## TECHNICAL MEMORANDUM

Re: **RI Phase 2 Modification No. 2  
Nevada Environmental Response Trust Site  
Henderson, Nevada  
Ramboll Environ Project No. 21-41400C, M03B**

Figure 1 RI Phase 2 Modification No. 2

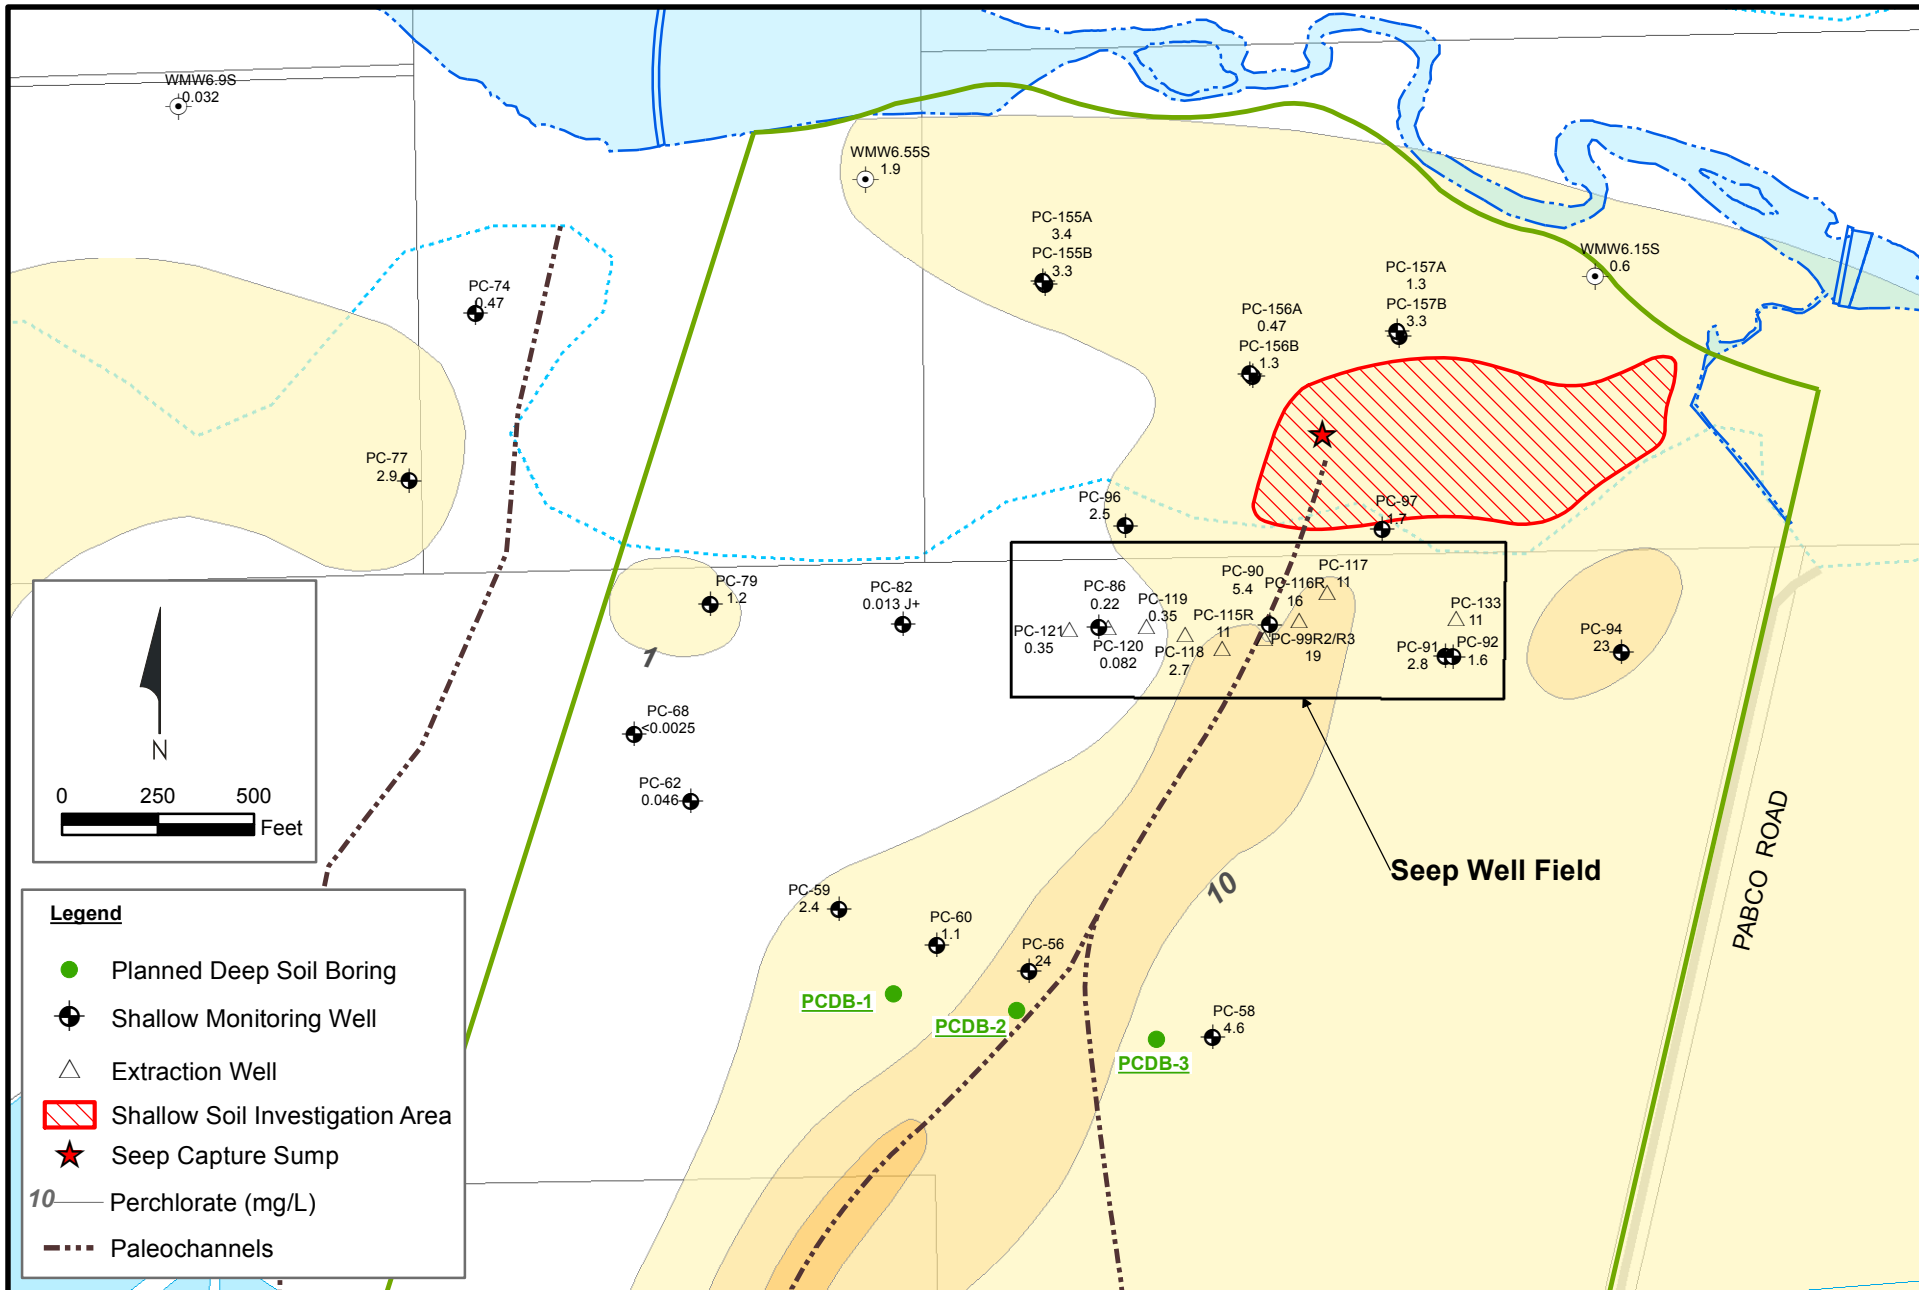
In order to better delineate the vertical extent of perchlorate and other chemicals of potential concern (COPCs) in the Upper Muddy Creek formation in the area upgradient of the SWF, we are recommending that these three borings be deepened to 150 ft bgs. Six additional soil samples will be collected from each boring at approximate depths of 100, 110, 120, 130, 140, and 150 ft bgs. The soil samples will be analyzed for the same constituents listed above. The additional soil sampling at borings PCDB-1, PCDB-2, and PCDB-3 will be conducted in accordance with the procedures in the approved Field Sampling Plan (FSP).
